Staff Report to the Technical Review Committee August 5, 2014

NARCOOSSEE COMMERCIAL CENTER

The applicant proposes to plat a 4 lot commercial development.

PROPOSED PLAT

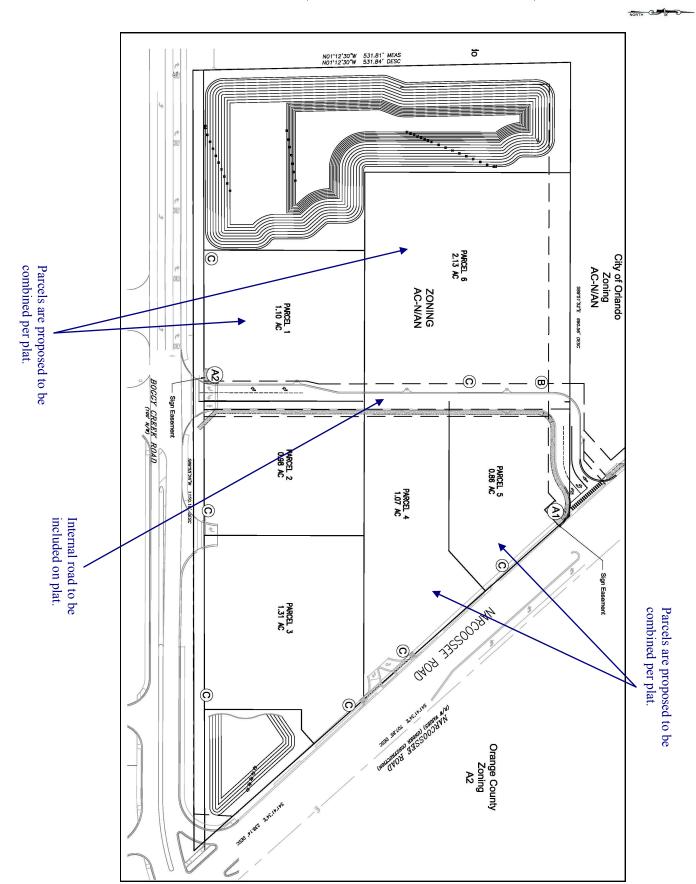
The applicant is requesting Major Subdivision approval for currently unplatted land. A four lot commercial development along with two drainage tracts are proposed. The previously approved Master Plan for the subject property consisted of a 6 lot development and an internal spine road. The AC-N zoning district requires a minimum site frontage of 45 ft. All proposed lots have frontage in excess of 100 ft. and as a result the consolidation of the number of lots from 6 to 4 is code compliant. Currently the internal spine road is not reflected as a tract on the plat and will need to be shown.

- 1. General Code Compliance. Development of the proposed project shall be consistent with the conditions in this report and all codes and ordinances of the City of Orlando, the State of Florida and all applicable regulatory agencies.
- 2. Previous Approval Consistency. The proposed development shall be consistent with the conditions of the previous approvals (MPL2011-00025, LDC2012-00306).
- 3. Tract. The internal spine road shall be provided as a tract for common usage.

1. The submitted plat does not include ingress/egress easements covering the joint use driveway network planned for the development. The applicant has stated that such easements will be provided under separate document and included in the Developer's Agreement when executed. However, City policy requires such easements to be included on the plat when properties are replatted. Applicant shall revise submitted plat to meet this policy requirement.

The name "NARCOOSSEE COMMERCIAL CENTER" cannot be used because it is too similar to an existing plat name of "NARCOOSSEE COMMERCENTER". Please choose a different name.

- 1. The surveyor must provide a one-and-the-same letter certifying that the legal description shown on the plat describes the same area as the legal description shown on the title opinion.
- 2. The stormwater easement recorded in 9838/6570 is shown on the title opinion but not on the plat or in the plat notes.
